**SERVICE BULLETIN****SB98.5****Outrigger Component Replacement****Serial Nos.: 1000-1870**  
(With optional outrigger  
cylinder kit)**Machines/Models: LX - Domestic & Euro**

**PURPOSE:** Replace the existing outrigger cylinder pads and mounting hardware.

**Figure 1**

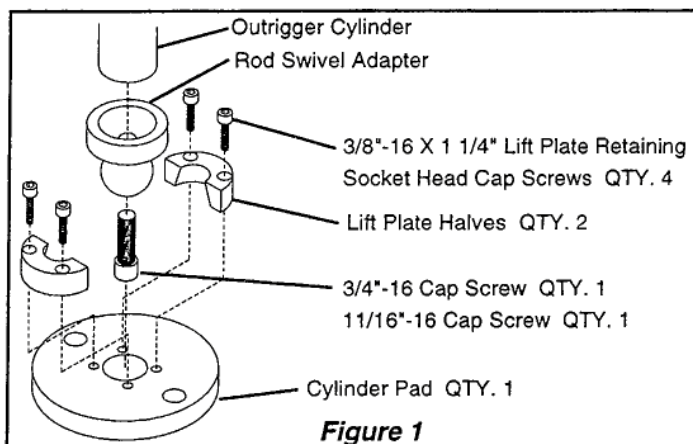
**OPERATION REQUIRED:** Replacement of all outrigger cylinder pads and mounting hardware per instructions below.

**PROCEDURE:** Read all instructions thoroughly and refer to figure 1 before starting. The procedure written below are the steps to replace one outrigger cylinder pad and retaining hardware. Repeat this procedure for each of the other three outrigger cylinders.

1. Ensure that the outrigger is completely retracted before installation of new cylinder pad and retaining hardware.
2. Remove existing cylinder pad and retaining hardware and discard.
3. Replacement Pad comes completely assembled. Remove the four Lift Plate Retaining Socket Head Cap Screws.
4. Attach the Rod Swivel Adapter to Outrigger Cylinder using the correct cap screw. (Apply medium strength thread lock to cap screw).

**NOTE: Two different threaded cap screws are included with this kit. Verify proper cap screw by threading cap screw in outrigger cylinder by hand. Do not force cap screw.**

5. Torque cap screw to 200ft. lbs./ 271Nm.
6. Install Lift Plate Halves, using four 3/8"-16 X 1 1/4" Socket Head Cap Screws. (Apply medium strength thread lock to cap screws).
7. Torque 3/8-16 X 1 1/4" cap screws to 31ft. lbs./ 42Nm.
